HISTORIC AND DESIGN REVIEW COMMISSION

HDRC CASE NO: 2015-330
ADDRESS: 633 S ST MARYS
LEGAL DESCRIPTION: NCB 179 BLK LOT 19 (UNIVISION REDEVELOPMENT SUBD) 2014-NEW ACCT PER SPLIT PER PLAT 9658/137-142 FILED 9/5/2013
ZONING: D RIO-3
CITY COUNCIL DIST.: 1
APPLICANT: Nic Whittaker
OWNER: CRP-GREP Elan Riverwalk Owner LP
TYPE OF WORK: Signage
REQUEST:

Historic and Design Review Commission
Design Review Committee
Report & Recommendation

Agave Project Identification

PAGE TITLE / ELEMENT TYPE
Sign Type 200: Parking Entrance Identification
Sign Type 201: Entry/Exit/Clearance Bar

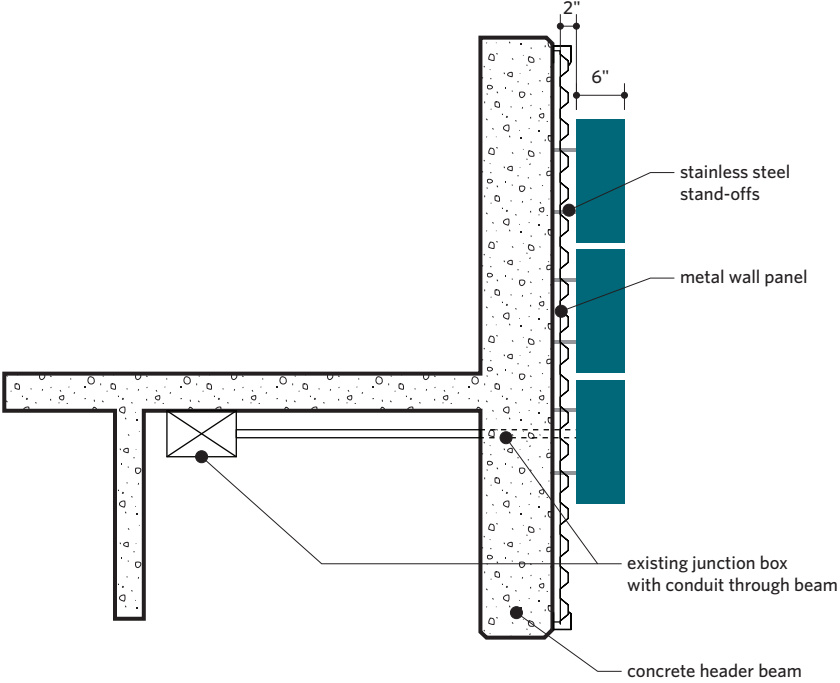
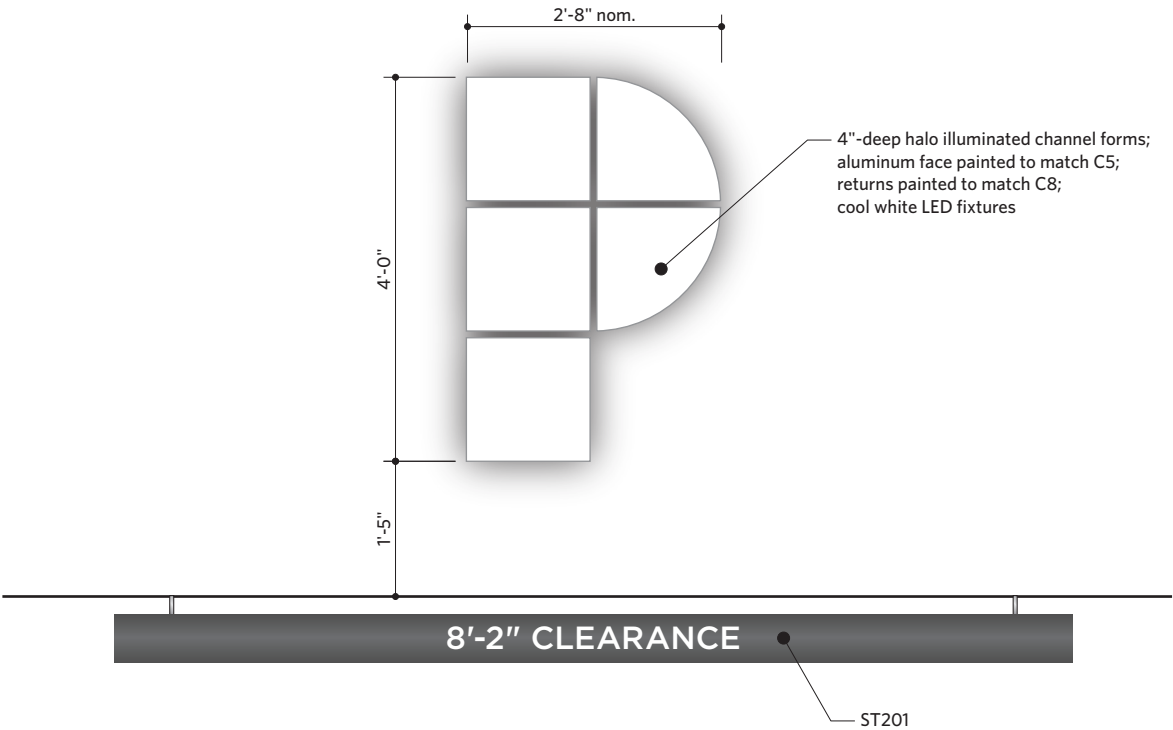
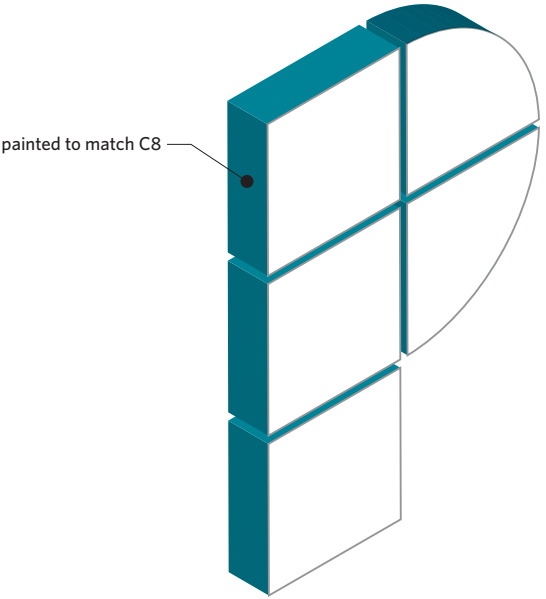
- e. The applicant has proposed parking identification signage to be 4' – 0" in height and 2' – 8" in width totaling approximately 11 square feet in size. This signage consists of the letter "P". The letter will be made of 4" deep halo illuminated channel forms with aluminum faces and will be backlit by LED's. This is consistent with the UDC Section 35-678(c)(1).
